Number: SB2X-32-22
Issued: April 12, 2016

SNS SUBJECT: 32-20 NOSE GEAR - Nose Landing Gear Strut Assembly Inspection

Number: SB2X-32-23
Issued: July 14, 2017

SNS SUBJECT: 32-20 NOSE GEAR - Nose Wheel Shimmy Reduction

Figure 01
Nose Landing Gear Strut Assembly Inspection

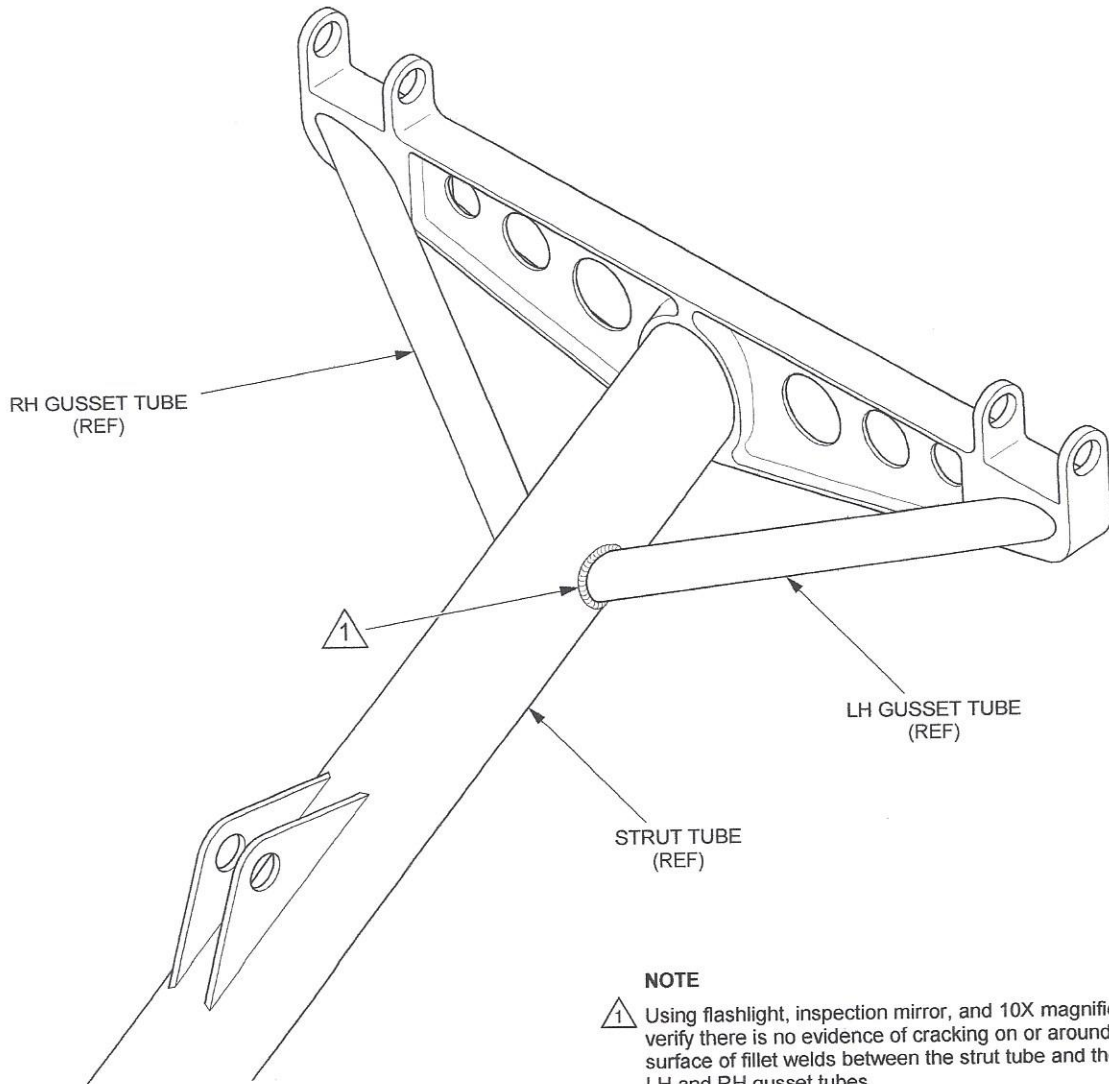
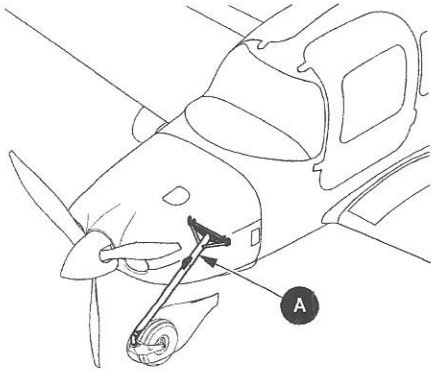
- (1) Using flashlight, inspection mirror, and 10X magnifier, verify there is no evidence of cracking on or around surface of fillet welds between the strut tube and the LH and RH gusset tubes. (See Figure 01)

WARNING: If cracking is identified in metal on or around surface of fillet welds, the aircraft is prohibited from flight until the nose landing gear strut assembly is replaced.

Figure 01
Nose Landing Gear Strut Assembly Inspection

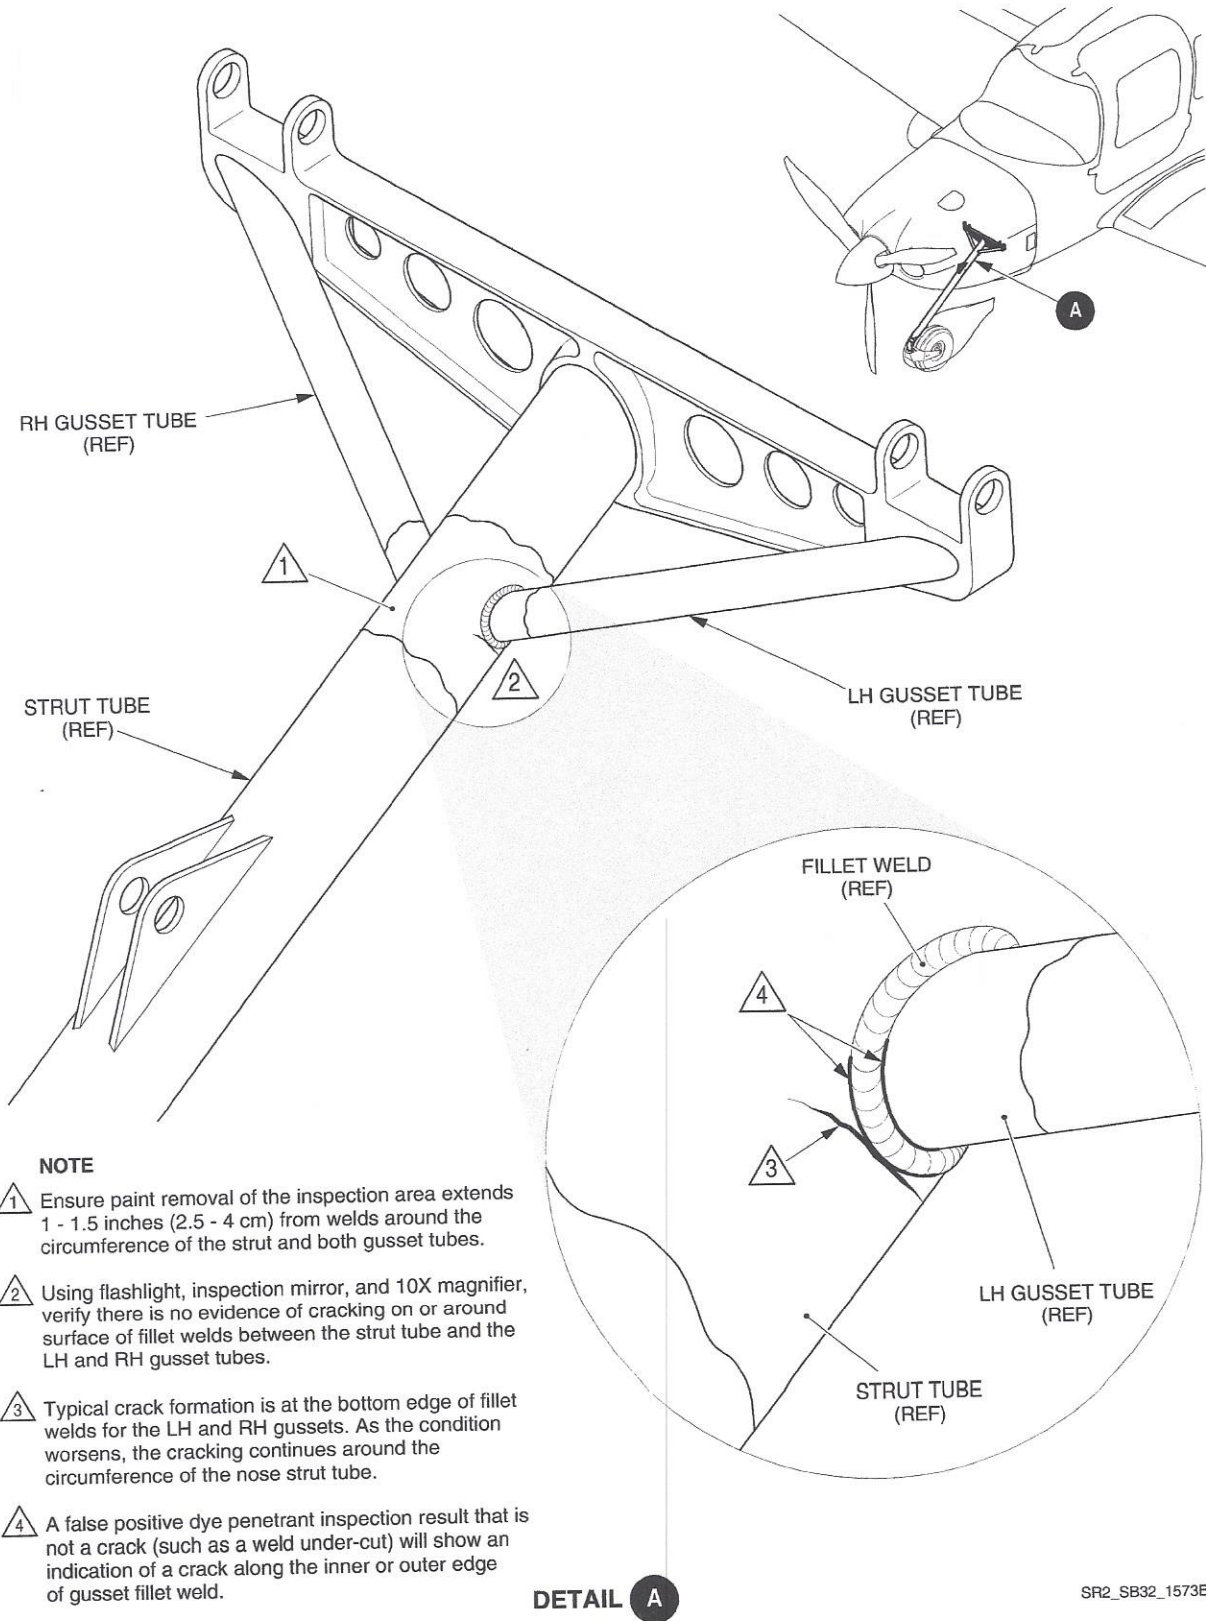
Note: Ensure paint removal of the inspection area extends 1 - 1.5 inches (2.5 - 4 cm) from welds around the circumference of the strut and both gusset tubes. (See Figure 01)

Note: Typical crack formation is at the bottom edge of fillet welds for the LH and RH gussets. As the condition worsens, the cracking continues around the circumference of the nose strut tube.

A false positive dye penetrant inspection result that is not a crack (such as a weld under-cut) will show an indication of a crack along the inner or outer edge of gusset fillet weld.

- (6) Using flashlight, inspection mirror, and 10X magnifier, verify there is no evidence of cracking on or around surface of fillet welds between the strut tube and the LH and RH gusset tubes. (See Figure 01)

Figure 01
Nose Landing Gear Strut Assembly Inspection

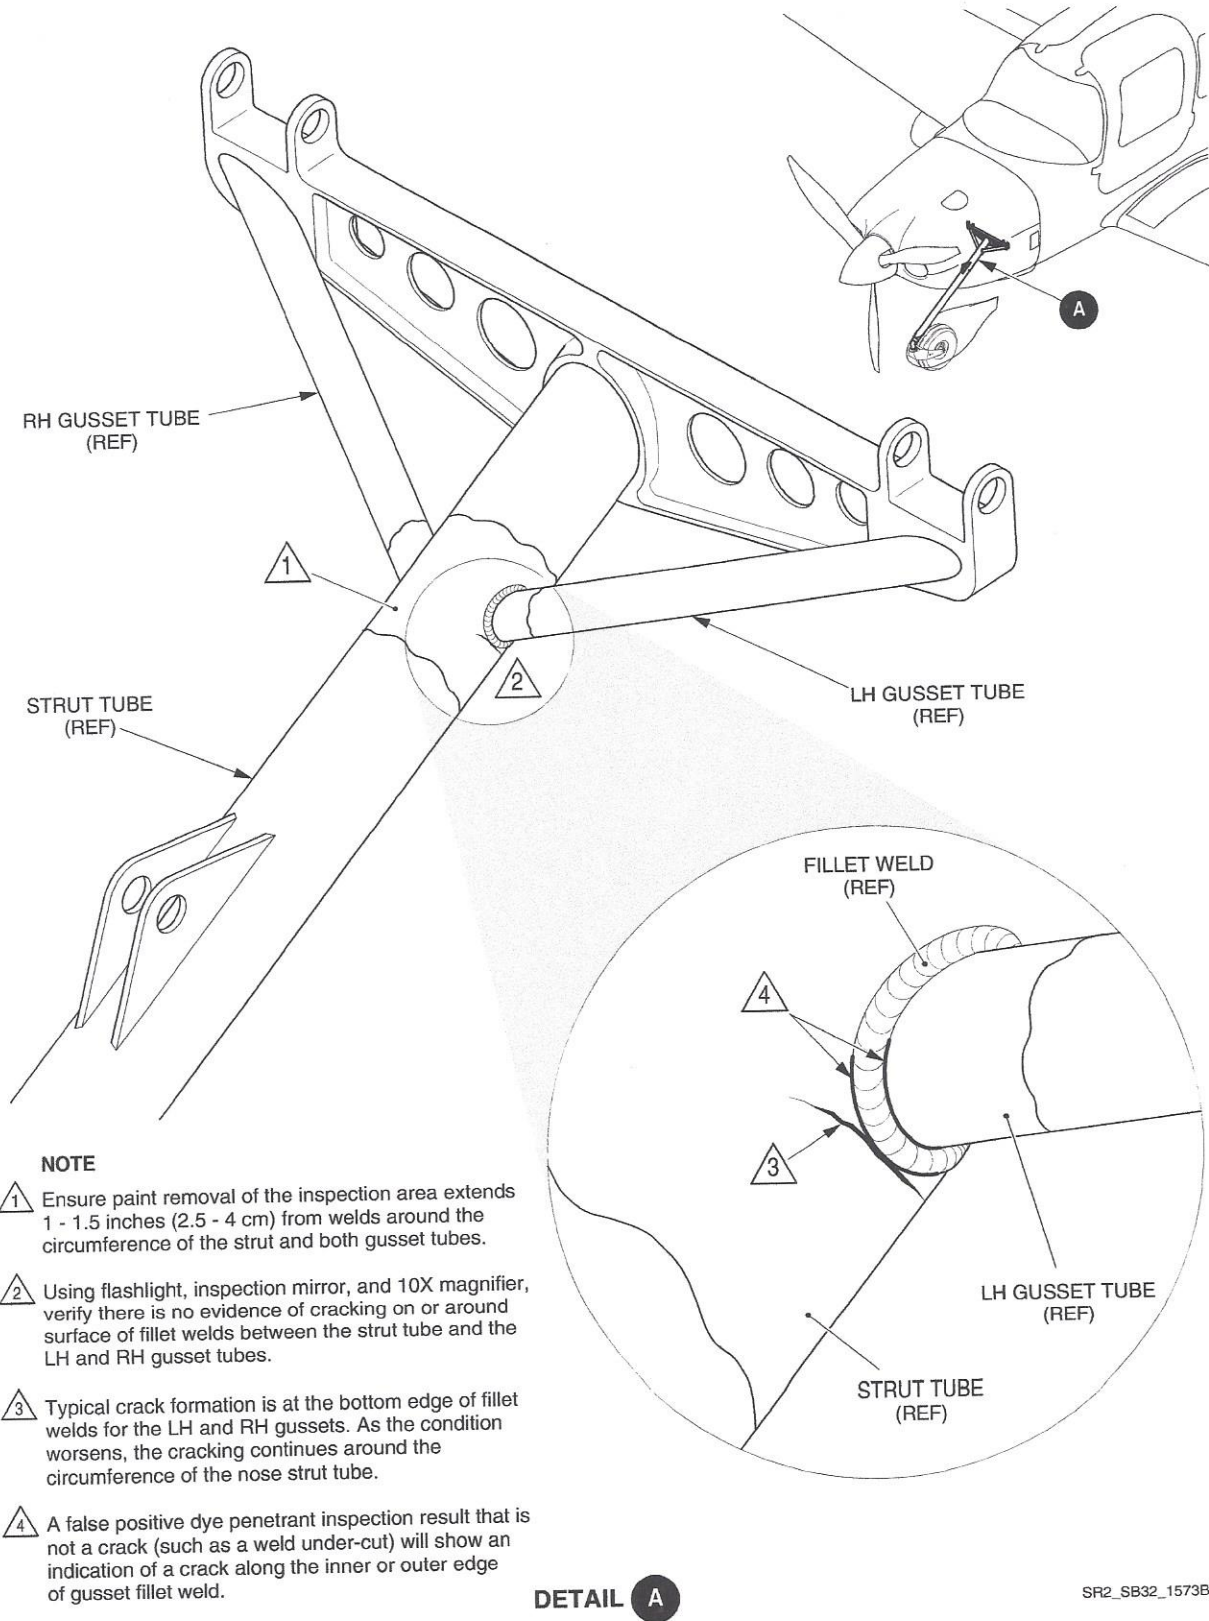
Note: Ensure paint removal of the inspection area extends 1 - 1.5 inches (2.5 - 4 cm) from welds around the circumference of the strut and both gusset tubes. (See Figure 01)

Note: Typical crack formation is at the bottom edge of fillet welds for the LH and RH gussets. As the condition worsens, the cracking continues around the circumference of the nose strut tube.

A false positive dye penetrant inspection result that is not a crack (such as a weld under-cut) will show an indication of a crack along the inner or outer edge of gusset fillet weld.

- (6) Using flashlight, inspection mirror, and 10X magnifier, verify there is no evidence of cracking on or around surface of fillet welds between the strut tube and the LH and RH gusset tubes. (See Figure 01)

Figure 01
Nose Wheel Shimmy Reduction

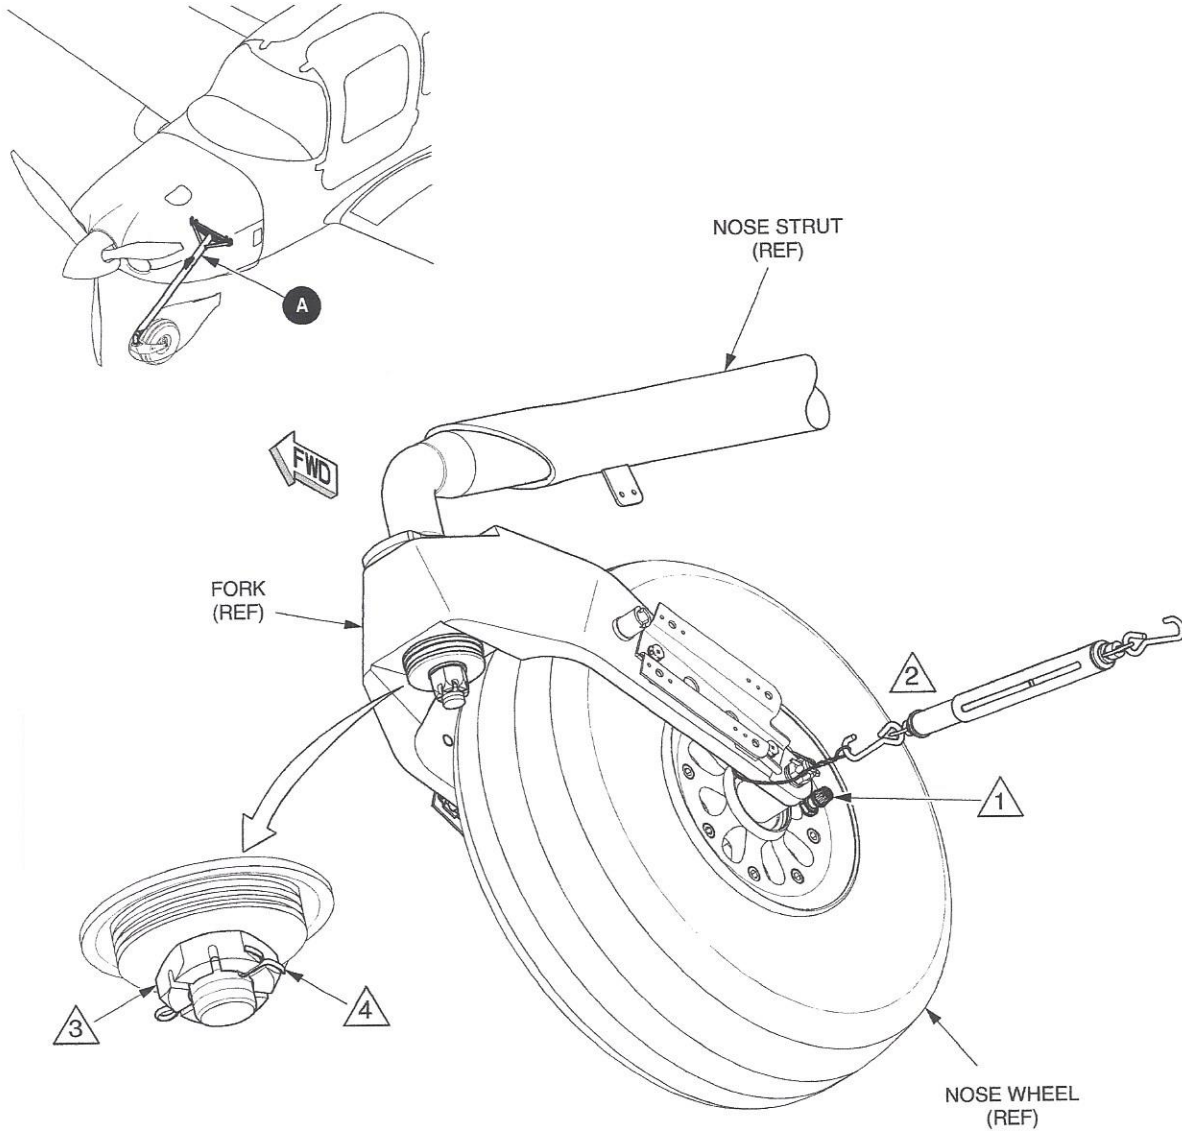
Note: For affected aircraft, Cirrus Engineering has changed the:

- NLG tire pressure from 40 - 90 psi to 40 - 50 psi, and
- force required to rotate the nose wheel fork from 20 - 25 lbs to 30 - 35 lbs.

- E. Adjust NLG tire pressure to 40 - 50 psi (276 - 344 kPa). (See Figure 01)
- F. Increase force required to rotate the nose wheel fork. (See Figure 01)

- (7) Secure nut with new cotter pin. Bend cotter pin legs around castellated spindle nut as shown. (See Figure 01)

- ① Adjust NLG tire pressure to 40 - 50 psi (276 - 344 kPa).
- ② Attach spring scale to axle.
- ③ Torque castellated spindle nut so a constant force of more than 49 lb (22.2 kg) is required to rotate nose wheel fork and wheel assembly. Loosen castellated spindle nut and re-torque so a constant force of 30 - 35 lb (13.6 - 15.9 kg) is required to rotate nose wheel fork and wheel assembly.
- ④ Install new cotter pin as shown.

Figure 01
Nose Wheel Shimmy Reduction

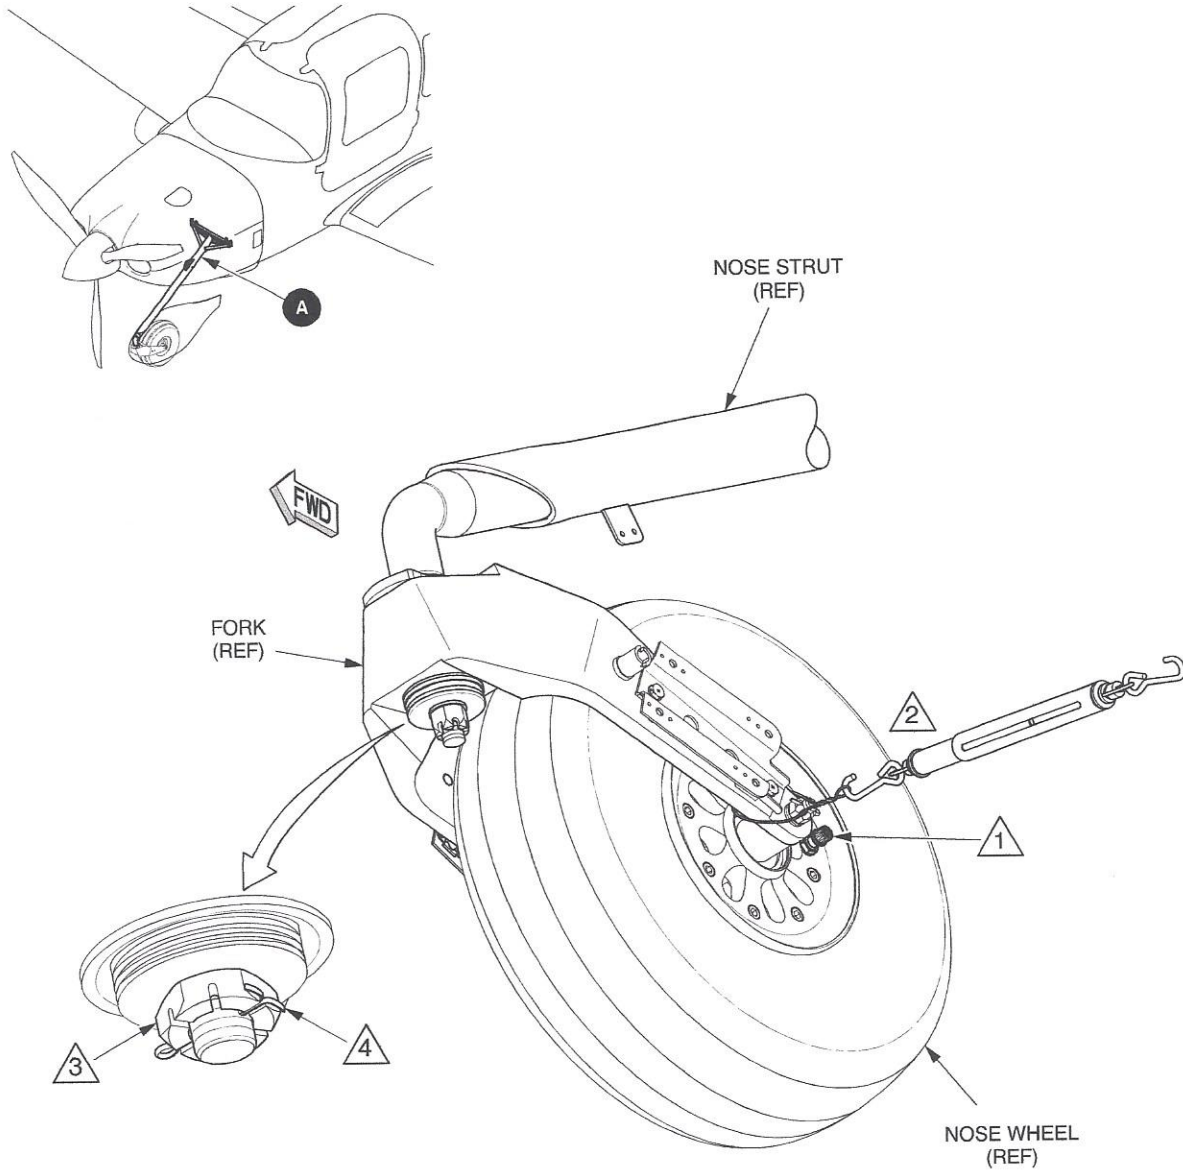
Note: For affected aircraft, Cirrus Engineering has changed the:

NLG tire pressure has changed from:

- 40 to 90 psi (276 to 621 kPa) or
- 40 to 50 psi (276 to 345 kPa)

to:

- 30 to 35 psi (207 to 241 kPa)
- Verify force required to rotate the nose wheel fork is 20 to 25 lbs (9.1 to 11.3 kg).

- E. Adjust NLG tire pressure to 30 to 35 psi (207 to 241 kPa). (See Figure 01)
 - F. Verify force required to rotate the nose wheel fork. (See Figure 01)
- (1) Acquire necessary tools, equipment, and supplies.

- (6) Secure nut with new cotter pin. Bend cotter pin legs around castellated spindle nut as shown. (See Figure 01)

- 1 Adjust NLG tire pressure to 30 - 35 psi (207 - 241 kPa).
- 2 Attach spring scale to axle.
- 3 Loosen castellated spindle nut and re-torque so a constant force of 20 - 25 lb (9.1 - 11.3 kg) is required to rotate nose wheel fork and wheel assembly.
- 4 Install new cotter pin as shown.
